# Access Compliance Report

## Public Rights-of-Way

### (Curb Ramps)

Intersection ID: 21585	Main Street: BROOKFIELD_DR	Cross Street: LOVETT_CR	Location:	S
ADA ID: 1CCE9BE74002	Ramp Type: Directional1	Initial Pass/Fail: Fail	Overall Compliance: No	Severity Score: 8.75
Codes/Mitigation Info/Possible Solution		Field Measurements/Component Compliance

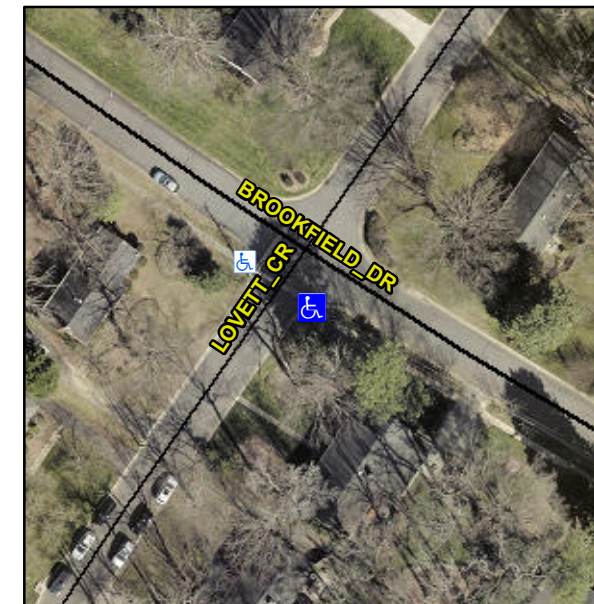
**R304.5.1**

Compliance	Description	Data	Compliance	Description	Data
N/A	Ramp Length (in)	55.0	N/A	Grade Break?	N/A
No	Ramp Width (in)	46.0	N/A	Grade Break Slope (%)	0.0
Yes	Ramp Slope (%)	2.2	N/A	Grade Break XSlope (%)	0.0
Yes	Ramp XSlope (%)	0.3			
N/A	Flare Type LT	N/A	N/A	Flare Type RT	N/A
N/A	Flare Slope LT (%)	N/A	N/A	Flare Slope RT (%)	0.0
N/A	Flare Traversable LT?	N/A	N/A	Flare Traversable RT?	N/A
N/A	Landing Length (in)	0.0	N/A	DWS Provided?	N/A
N/A	Landing Width (in)	0.0	N/A	DWS Contrast?	N/A
N/A	Landing Slope (%)	0.0	N/A	DWS Length (in)	N/A
N/A	Landing X Slope (%)	0.0	N/A	DWS Full Width?	N/A
N/A	Landing Curb? (Y/N)	N/A	N/A	DWS Offset LT (in)	N/A
N/A	Shared Landing?	N/A	N/A	DWS Offset RT (in)	N/A
N/A	Gutter Ponding?	0.0	N/A	Gutter Slope (%)	N/A
N/A	Gutter Lip Ht (in)	0.0	N/A	Gutter X Slope (%)	N/A
N/A	Painted X Walk1?	No		Road Slope (%)	4.0
	X Walk 1 Direction	To W		Road X Slope (%)	5.2
	X Walk 1 Width (in)	N/A		Clear Space?	N/A

X Walk 1 Slope (%)	4.0	N/A	Clear Space to XWalk (in)	N/A
	X Walk 1 X Slope (%)	5.2	N/A	Storm Grate/Utility Hazard?	N/A
N/A	Ramp inside XWalk1?	N/A		Storm Grate/Utility Type	
N/A	Any Obstructions?	N/A			N/A
	Obstruction Type		Yes	Surface Condition? (G/P)	Good
			N/A	Curb Slope (%)	18.8

**Remove & Replace Entire Ramp.**
